STAFF REPORT

Review of Glendale Water and Power's 2019 Integrated Resource Plan

Gavin Newsom, Governor
November 2019 | CEC-200-2019-019

Figure 2: Glendale and CEC Peak Forecasts 2019-2030 (MW)

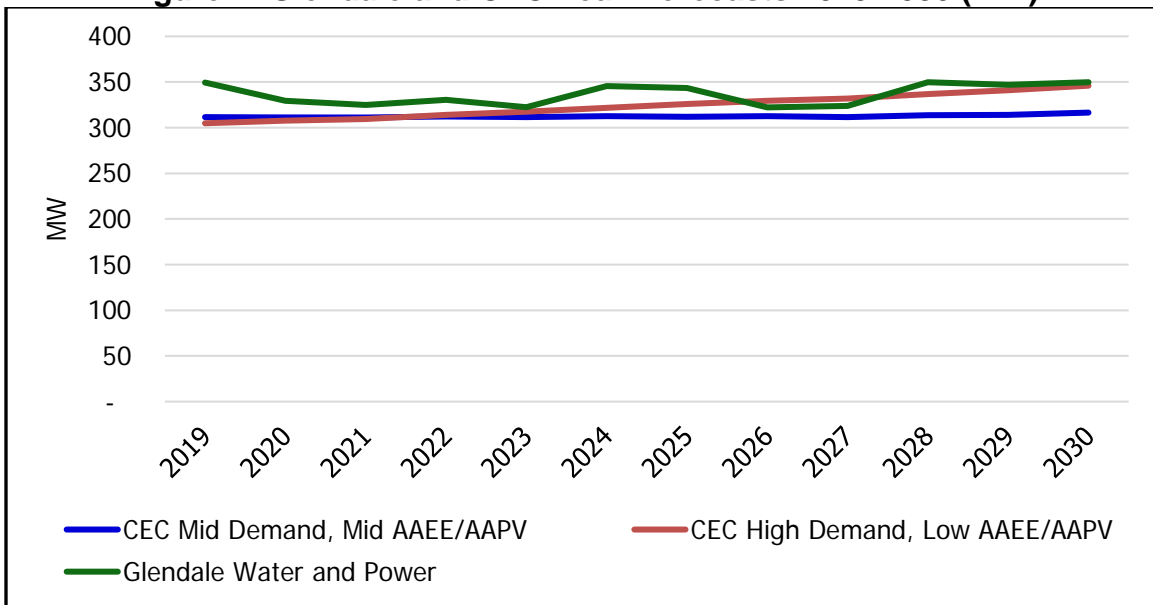
As can be seen in **Figure 2**, the forecasted peak demand is typically above the *2018 IEPR Update* high-demand, low-AAEE/AAPV forecast. This is likely due to a difference in assumed load shape.
